Docket Item # 12  
BAR CASE # 2008-0168

BAR Meeting  
October 15, 2008

**ISSUE:** Alterations  
**APPLICANT:** Elizabeth Reno and Roy Wuchitech  
**LOCATION:** 408 North Union Street  
**ZONE:** RM/Residential

**Figure 3: Existing Rear Elevation**

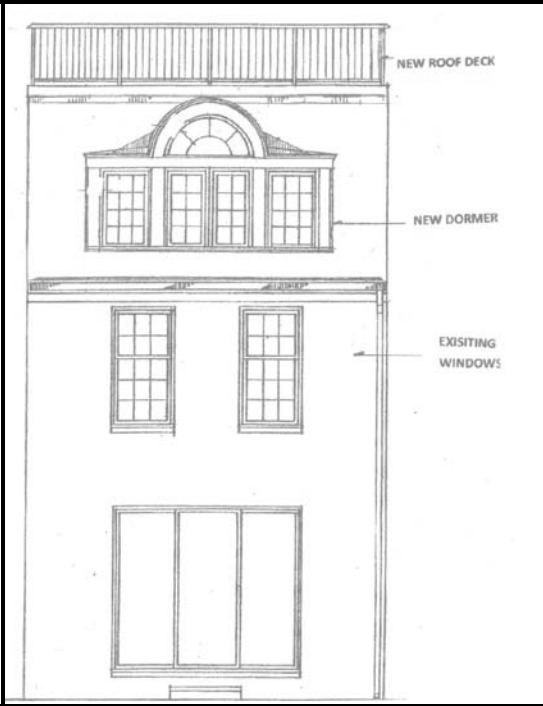
While staff generally discourages the use of simulated divided light windows, in this situation due to the desire for the new window to have the same muntin profile as the remaining windows on the façade, Staff believes the use of simulated divided lights would be appropriate. Staff finds that because the houses in this development along North Union have a variety of Palladian windows of differing styles and because the Board has approved Palladian windows extremely similar if not identical to the one proposed in this application, Staff recommends approval of the proposed window. Additionally due to the fact that the siding on the dormer will be minimally visible and due to its location difficult to maintain, staff finds that the use of Hardiplank would not be an inappropriate building material for this alteration.

Although most of the roofs of the townhouse complex appear to be gable designs from the street, they are actually flat for a large portion of the central area. Many homeowners have adapted the large attic areas below for living space and desire to use the flat roof areas for observation of the Potomac River.
